RE: DEFK9024 - REPLACEMENT OF A VEHICULAR TYPE EXHAUST/VENT SYSTEM AT THE WV ARMY NATL. GUARD, KINGWOOD, WV

Addendum #1 -FMS # 4, Kingwood, WV

Exhausts Removal System replacement for WVARNG C&FMO at

ADDENDUM NO. 4**FMS # 4, Kingwood, WV****18 June 2009****Prepared By: Jonathan L. Neal****Submitted By: MAJ. Michael J. Beckner
Facilities Manager****RFQ Number: DEFK9024****Exhausts Removal System replacement for WVARNG C&FMO at****FMS # 4, West Virginia Army National Guard****Kingwood, West Virginia 26537**

FRONT OF BUILDING

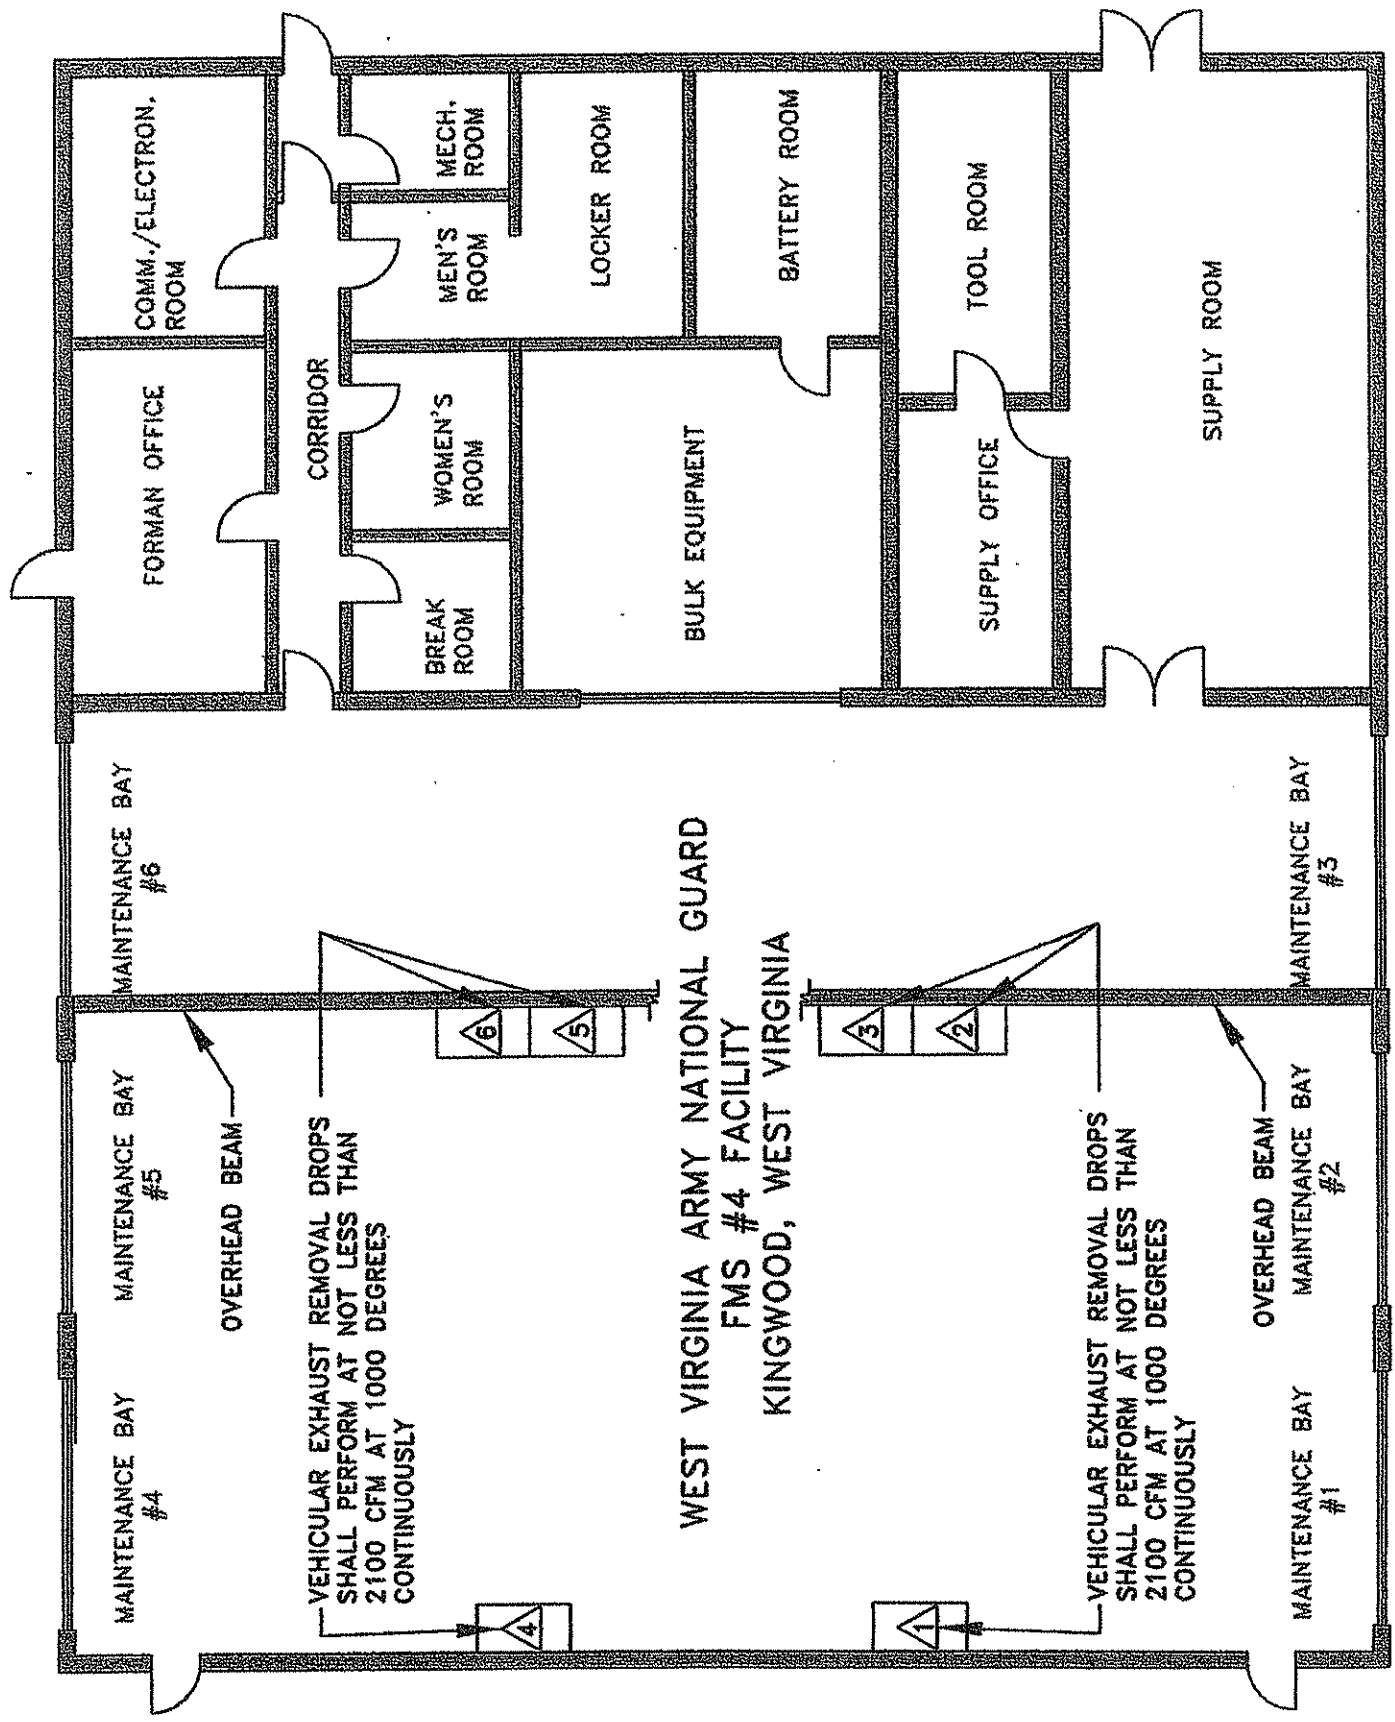
- A. The layout for the vehicular exhaust removal systems has been revised. (Please see attached drawing.) Delete Page 13 layout drawing of the contract and replace with attached drawing.
- B. Contractor shall follow the roof manufactures (Carlisle SynTec Incorporated) recommendations for all roof alterations and repair. All components of the specified roofing system shall be products of Carlisle SynTec Incorporated or accepted by Carlisle as compatible.
- C. All work pertaining to the roof system shall be performed by a qualified roofing contractor, whom has experience working with the Carlisle SynTec Incorporated products. The awarded contractor is responsible for insuring that the roof system is water tight after all alterations.

FRONT OF BUILDING

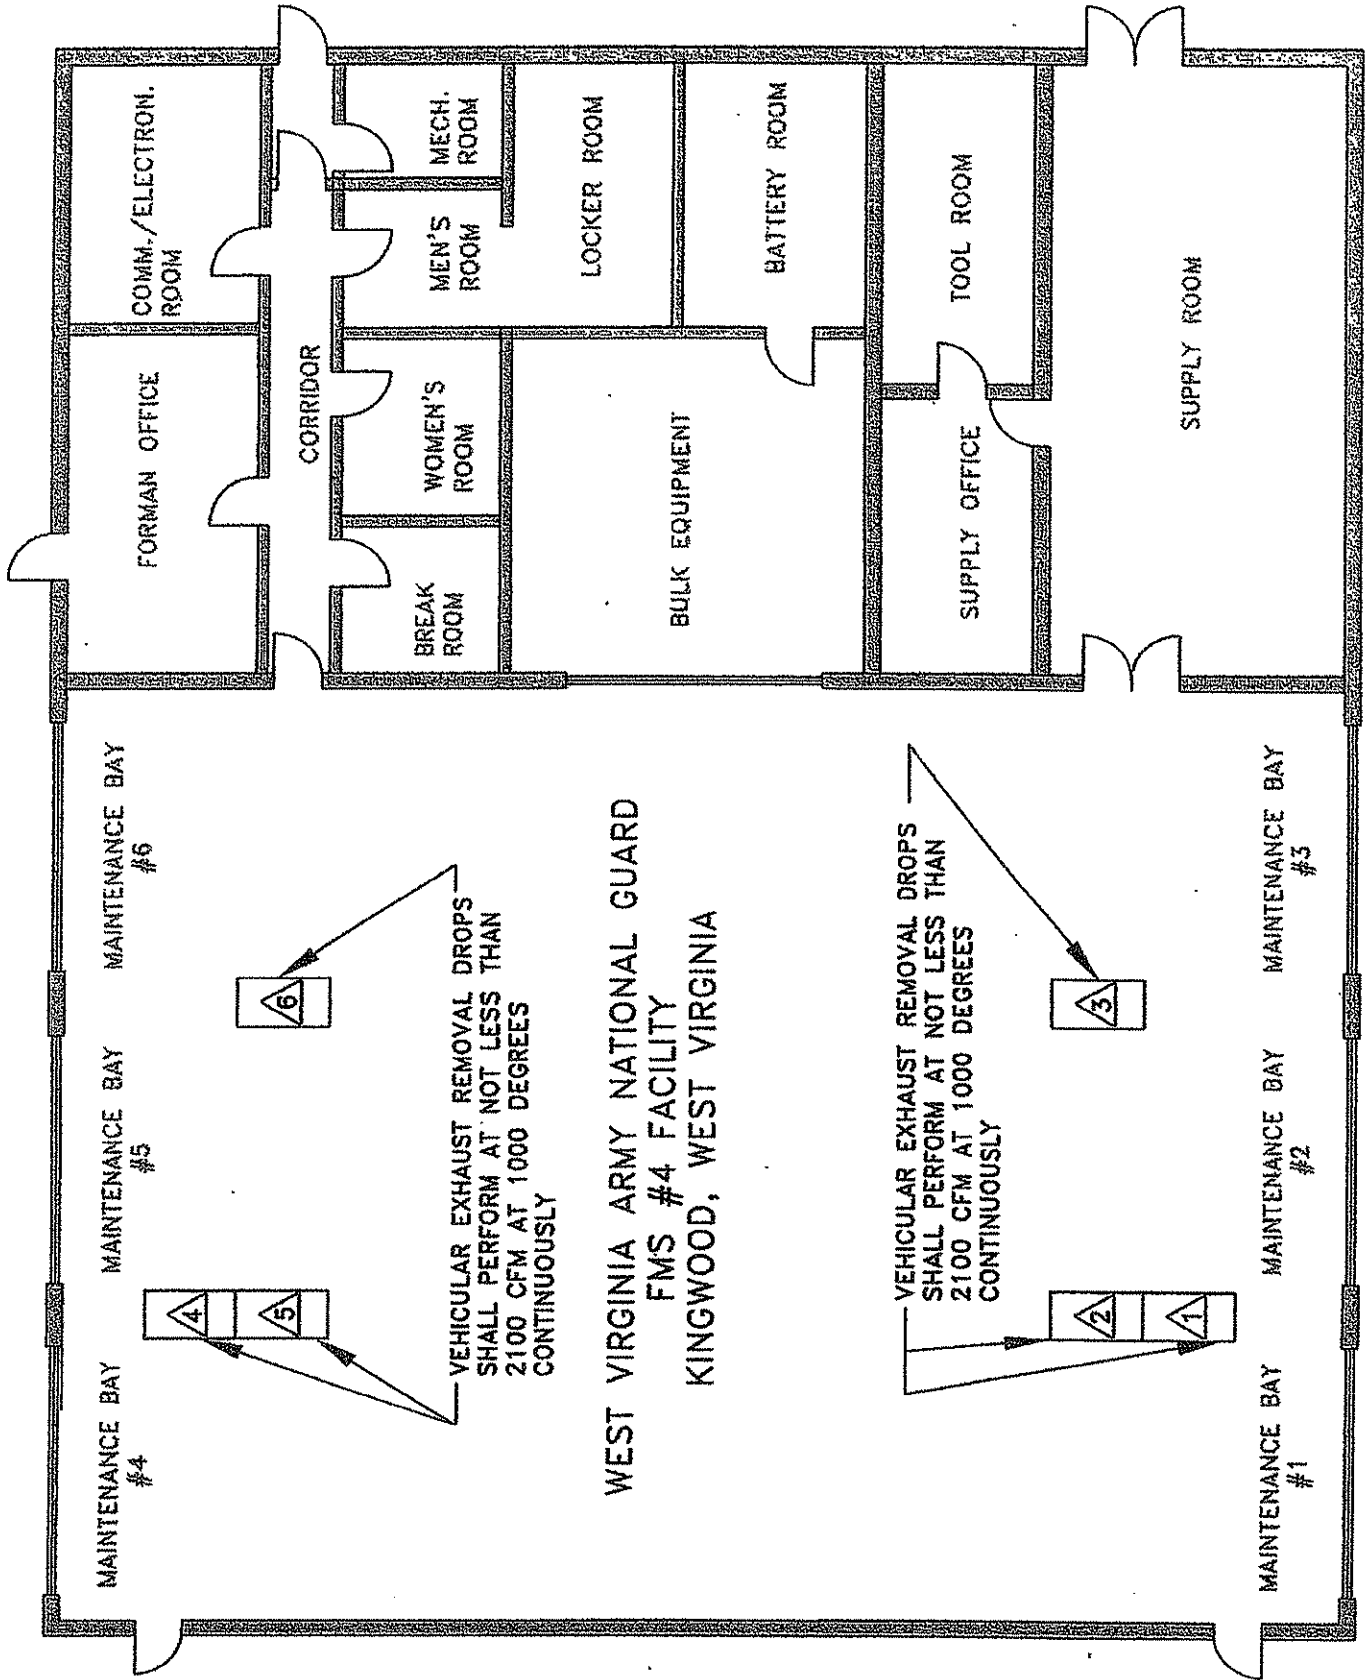
VEHICULAR EXHAUST REMOVAL DROPS SHALL PERFORM AT NOT LESS THAN 2100 CFM AT 1000 DEGREES CONTINUOUSLY

VEHICULAR EXHAUST REMOVAL DROPS SHALL PERFORM AT NOT LESS THAN 2100 CFM AT 1000 DEGREES CONTINUOUSLY
